Possible Next Steps for Roundtable Proposed GBAS Procedures (4, 5 & 6)

April 2023

Roundtable-proposed GBAS Procedures

Roundtable Proposed GBAS Procedure 5

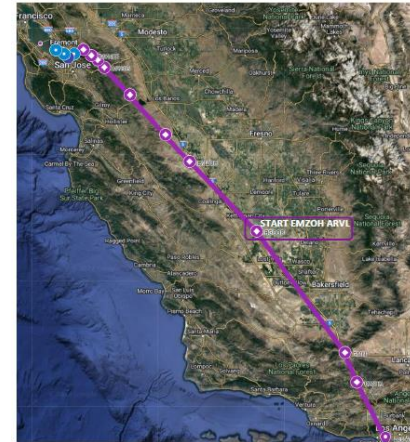
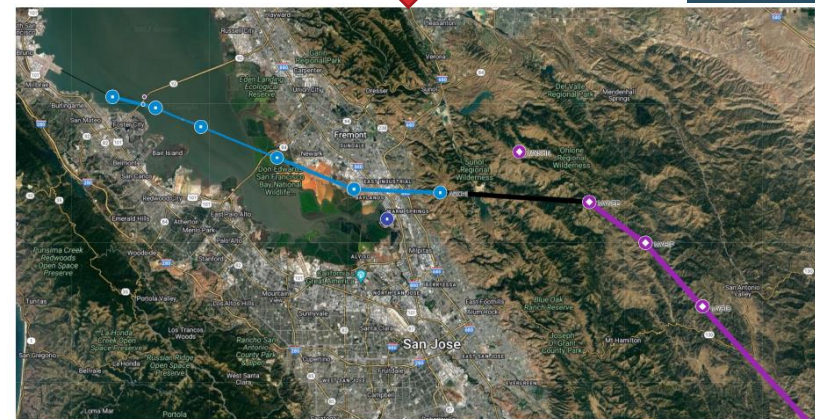
- Roundtable Proposal:
Move southeast SFO arrivals to share the OAK arrival stream
- GBAS Team Response:
 - Beyond the scope of the GBAS project
 - Pursue via FAA CEO
- Possible Next Steps:
 1. Nothing since outside of GBAS scope
 2. Suggest FAA review concept and determine feasibility outside of SFO GBAS project

Note: *Concept is to allow SFO arrivals to move from the SERFR STAR to the EMZOH STAR and create a link to the existing 28R arrival RNAV or similar concept*

Roundtable Proposed GBAS Procedure 6 *Dual Offset Approaches to 28L and 28R*

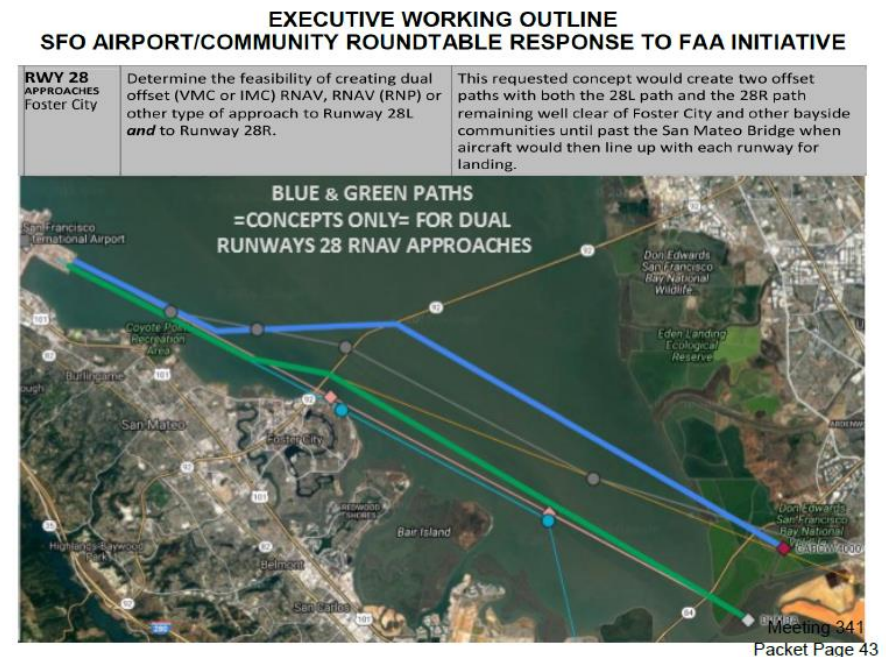
- Roundtable Proposal:
Dual offset approaches to keep arrivals further northeast over the Bay
- GBAS Team Response:
 - Not pursuing due to safety issues
 - Revisit after FAA evaluations of simultaneous approach operations
- Possible Next Steps:
 1. Nothing since safety issues cited
 2. Put on hold until the FAA has completed its ongoing evaluation of simultaneous approach operations and then resubmit to GBAS Team
